Results of the NOD sent to TCEQ on the El Paso exemption

Re: Technical Notice of Deficiency No. 1
Application for Aquifer Exemption
Class V Authorization 5X2700062, Tracking No. 12421324-1
CN602957060/RN104809389
Kay Bailey Hutchison Desalination Plant

Re: EPWU Application for Aquifer Exemption
Class V Authorization 5X2700062, Tracking No. 12421324-1
CN602957060/RN104809389
Kay Bailey Hutchison Desalination Plant

Exhibit 3 – Fault structure map - injection well site area

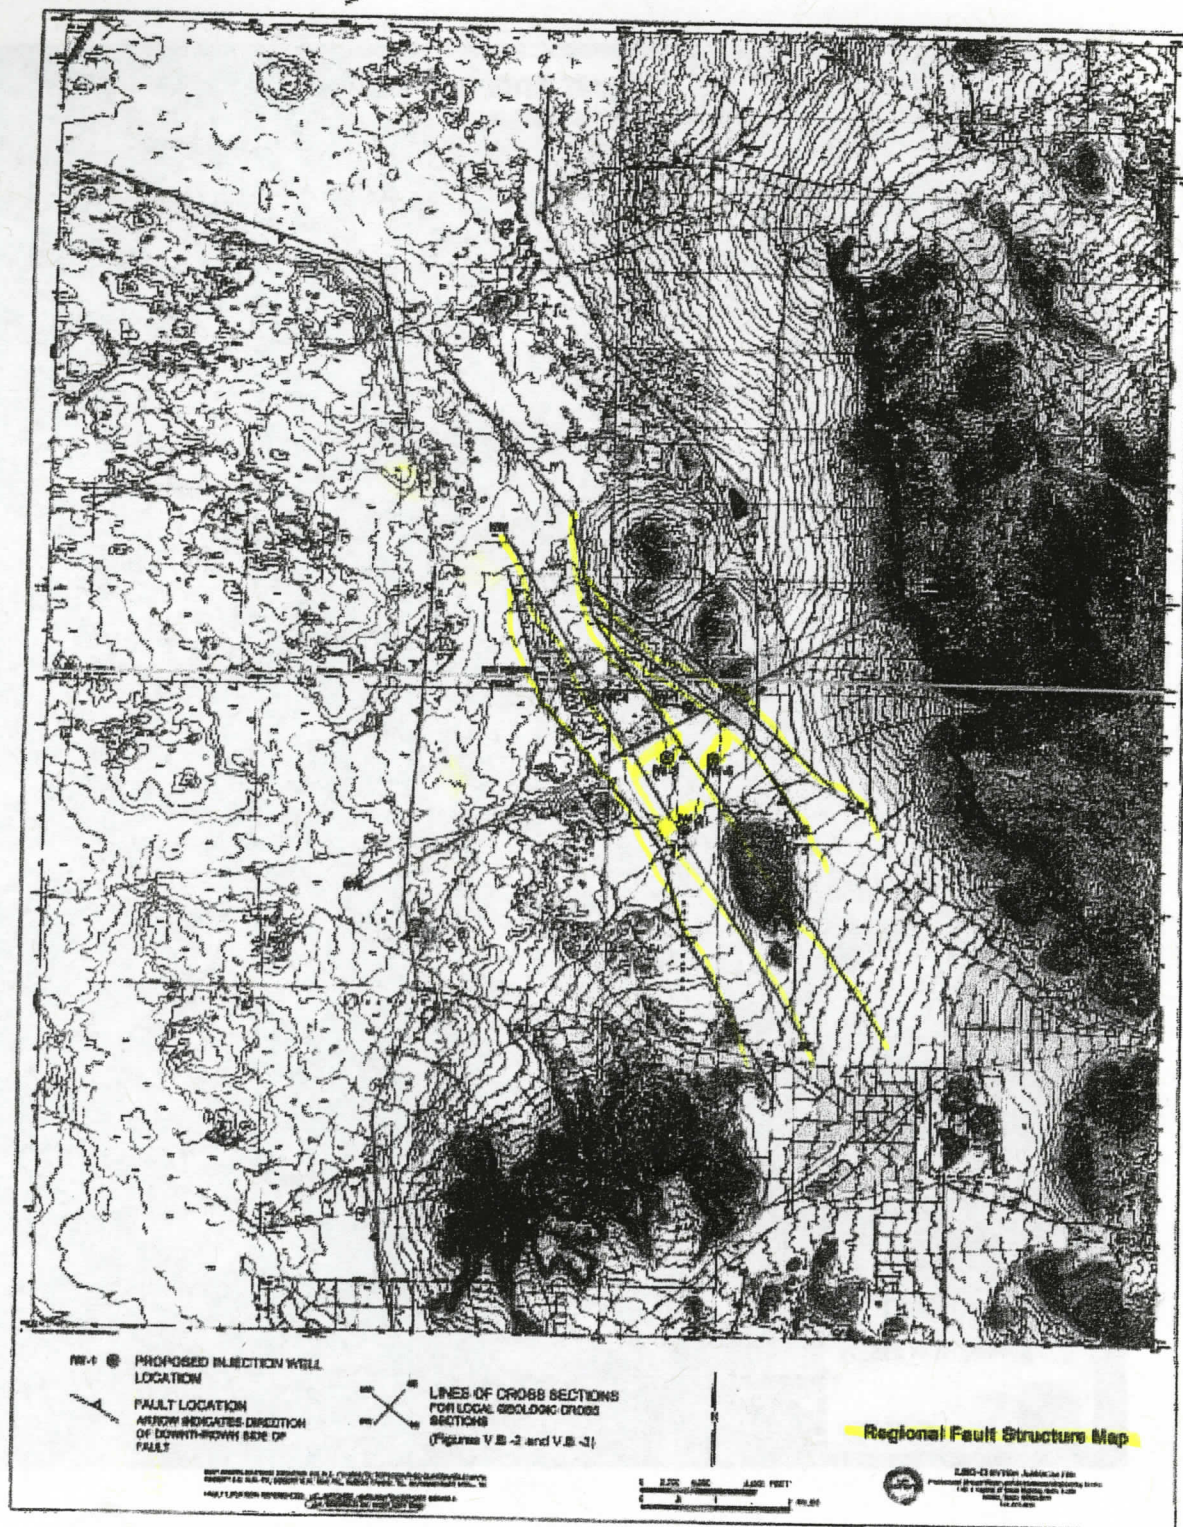
faults possibly causing a more SE flow at the well sites -

Exhibit 4 – Bouguer anomaly map - injection site area (from Granillo, 2004)

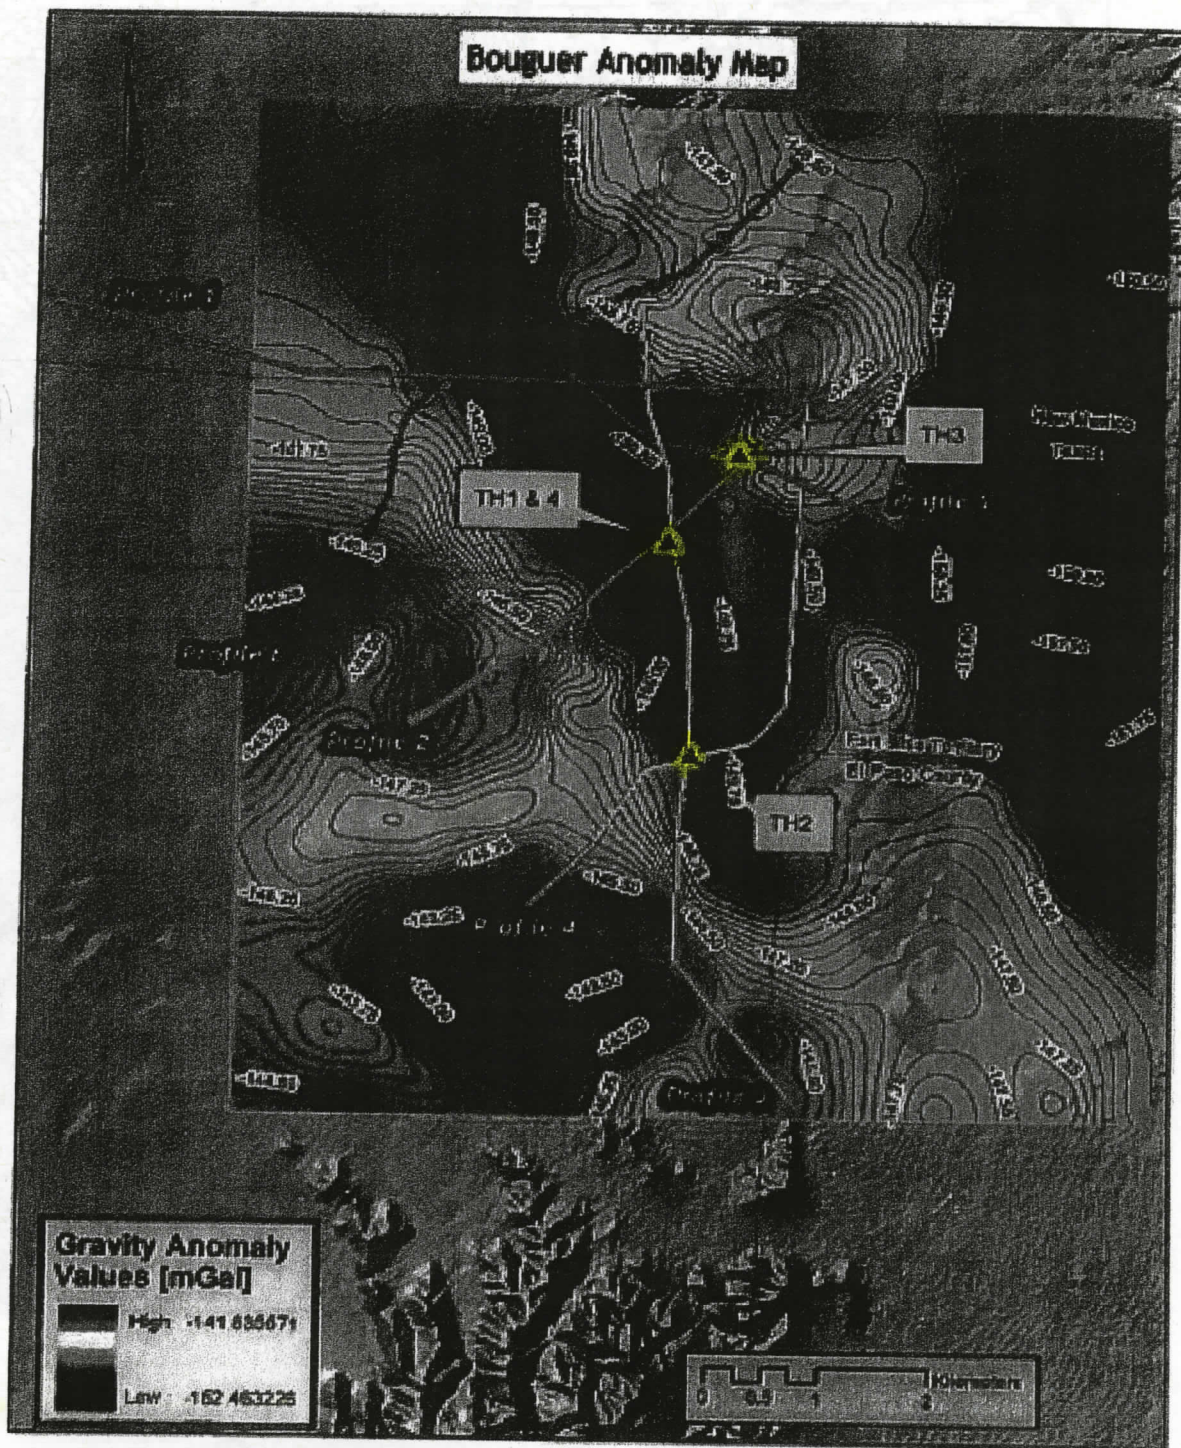
*shows
Less mass in the
dark regions
to what depth?*

Exhibit 5 – McGregor Range heat flow map (Witcher, 1997)

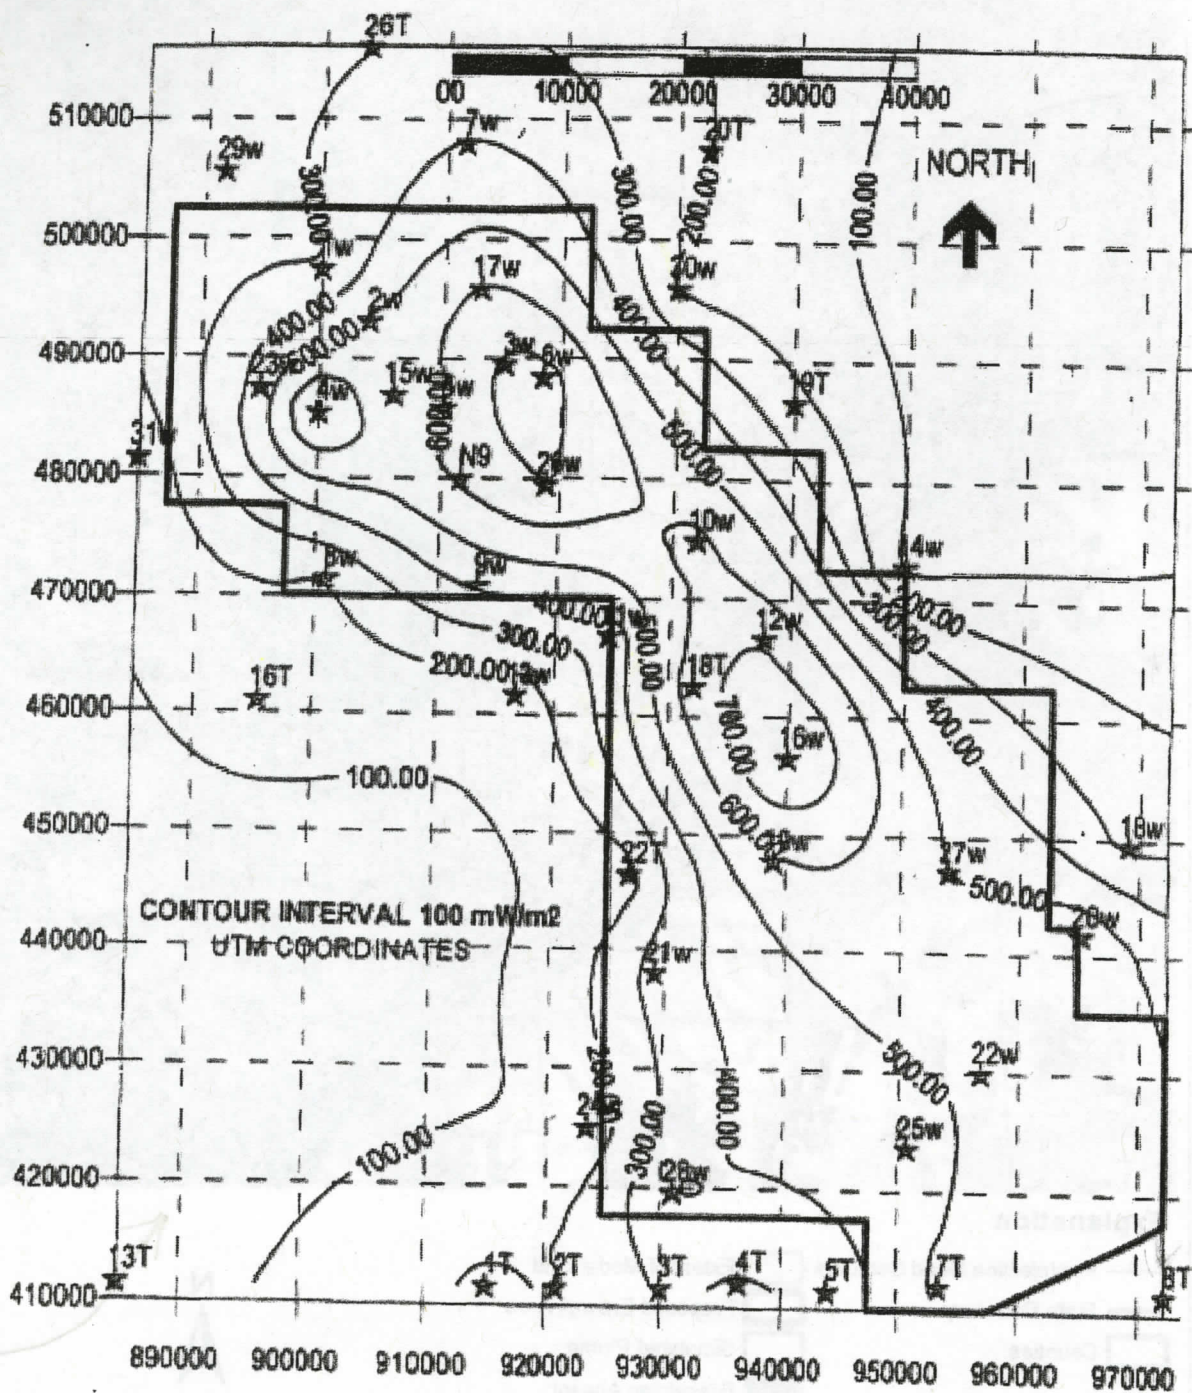
*No markers
to judge what
we're looking at*

*Not enough explanation to
show anything about*
